CITY OF ALBUQUERQUE

**RE: Dennis Chavez Community Center Ph 2 addition
715 Kathryn SE
Grading and Drainage Plan Stamp Date: 12/4/19
Hydrology File: L14D013**

Based on the submittal received on 1/23/20, the above-referenced Grading and Drainage Plan cannot be approved until the following are corrected:

C-101

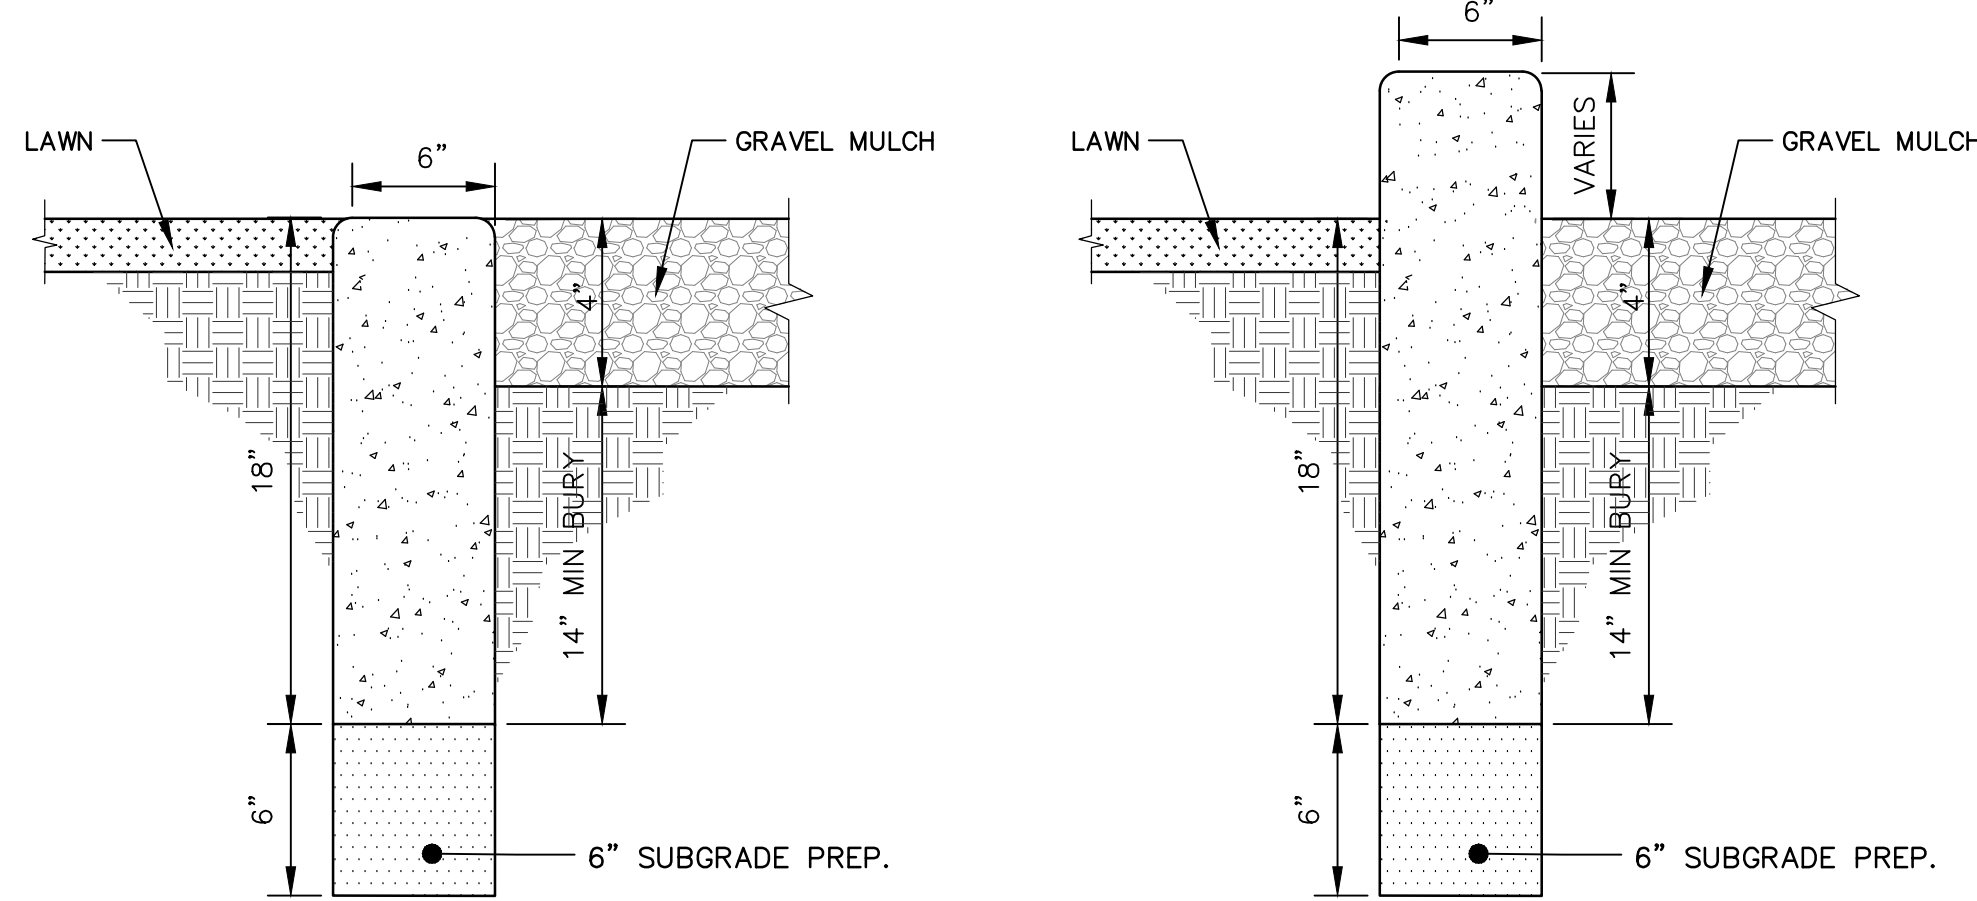
2. The existing contours need to be darkened to be visible and the hatching screened back on the addition. Show the work to demo the existing addition and build the new larger one. It may make more sense to break the existing condition and proposed addition into two viewports.

3. How will the existing stormwater quality pond be relocated? Ensure it will still capture its required stormwater quality volume (SWQV), plus the additional SWQV created by this project.

4. Please provide the SWQV calculations for each basin draining to each pond, including to the existing west pond and the relocated existing pond. The stormwater quality ponds need to be sized for the areas draining to them. The pond on the west side of the building can probably be upsized to capture any of the bypass volume.
